Service Advisory

Applicable Games: Rush

Models: Premium, LE

Serial Numbers: All numbers before #330402C

Previous Switch and Bracket

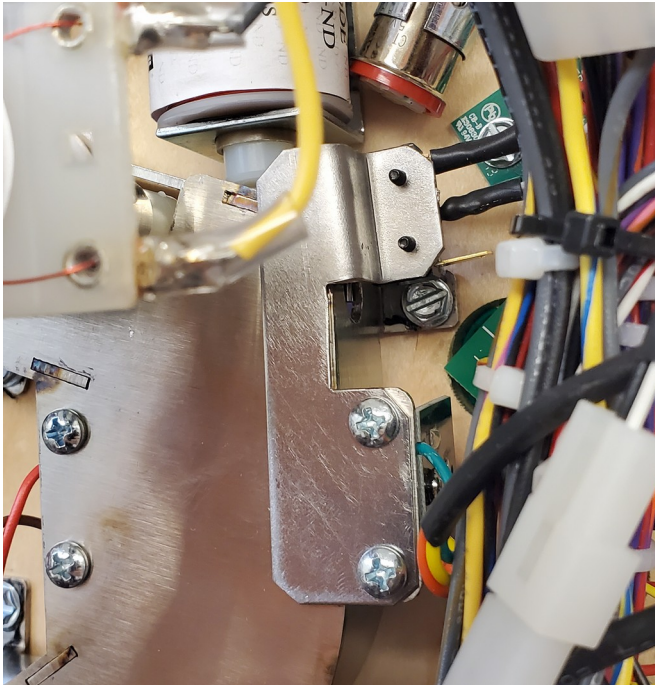
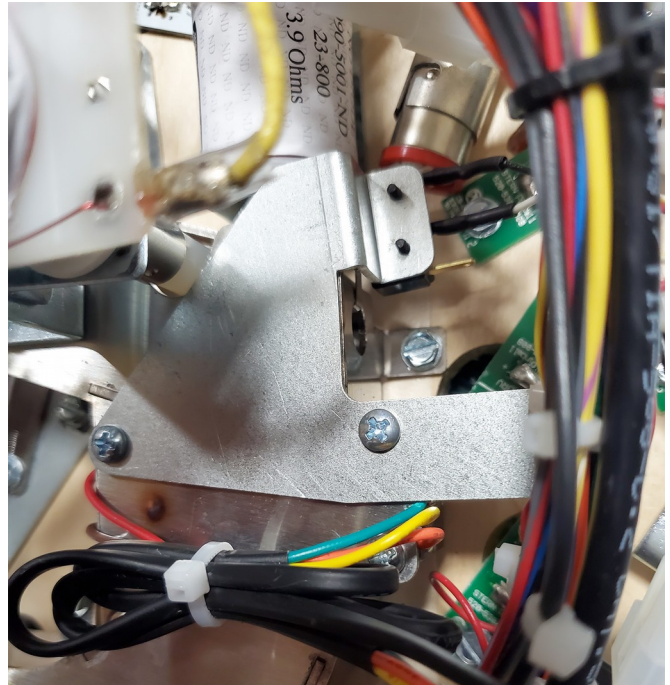
To improve the switch activation of switch #41 (Lower Side Scoop), our mechanical engineering department highly recommends replacing the current switch and bracket assembly on your game with kit number 502-8018-00; reference the pictures below. Please contact your distributor if your game requires this kit.
